SUBJECT: VIRGINIA ELECTRIC AND POWER COMPANY,  
North Anna Power Station Units No. 1 and 2

AMENDMENT TO FACILITY OPERATING LICENSE

Amendment No. 39  
License No. NPF-4

SAFETY EVALUATION BY THE OFFICE OF NUCLEAR REACTOR REGULATION

Figure 3.2-2  $K(Z)$  - Normalized  $F_Q(Z)$  as a Function of Core Height

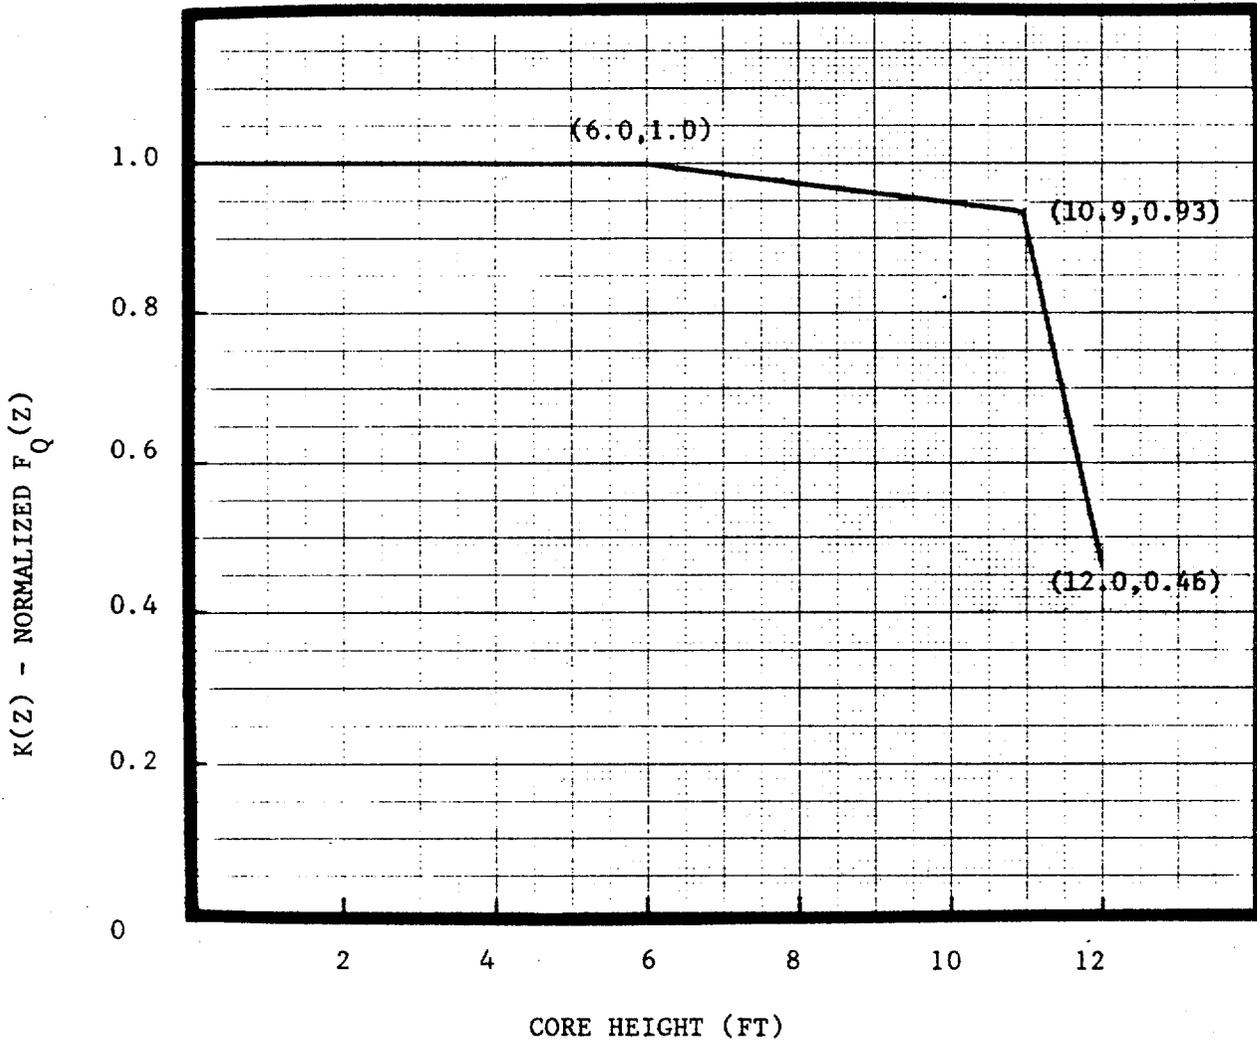
3.2.2 F<sub>Q</sub>(Z) shall be limited by the following relationships:

$$F_Q(Z) \leq \frac{[2.14]}{P} [K(Z)] \text{ for } P > 0.5$$

$$F_Q(Z) \leq [4.28] [K(Z)] \text{ for } P \leq 0.5$$

and K(Z) is the function obtained from Figure 3.2-2 for a given core height location.

Figure 3.2-2  $K(Z)$  - Normalized  $F_Q(Z)$  as a Function of Core Height

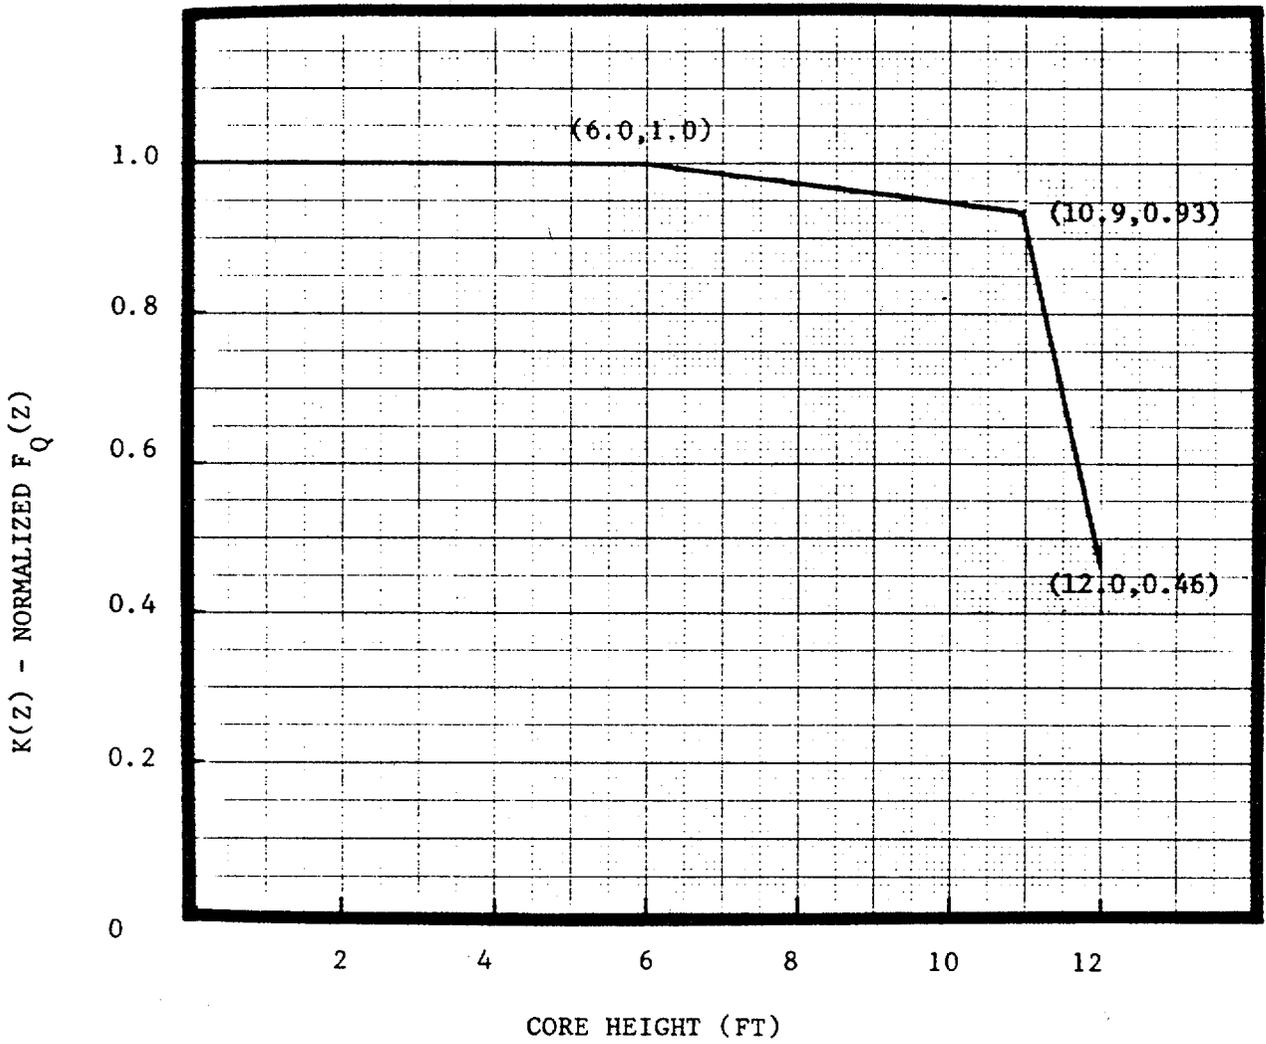
3.2.2 F<sub>Q</sub>(Z) shall be limited by the following relationships:

$$F_Q(Z) \leq \frac{[2.14]}{P} [K(Z)] \text{ for } P > 0.5$$

$$F_Q(Z) \leq [4.28] [K(Z)] \text{ for } P \leq 0.5$$

and K(Z) is the function obtained from Figure 3.2-2 for a given core height location.
